Proposal #01: 1204-08-73, WISC 2025145
Mount Horeb - Madison
CTH G to West Verona Ave/Epic Ln
USH 18
Dane County

1204-08-74, WISC 2025146
Mount Horeb - Madison
West Verona Ave/Epic Ln to STH 69
USH 18
Dane County

This is Addendum No. 01, which provides for the following:

ADDENDUM NO. 01
1204-08-73, 1204-08-74
January 6, 2025

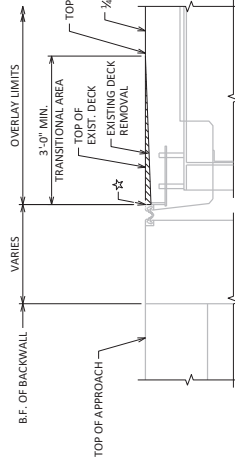
Revised Plan Sheets	
Plan Sheet	Plan Sheet Title (brief description of changes to sheet)
571	Revised page to add bid item 509.9015.S for B-13-0052.
596	Revised page to add bid item 509.9015.S for B-13-0383.

The following 8½ x 11-inch sheets are attached and made part of the plans for this proposal:
Revised: 571 and 596.
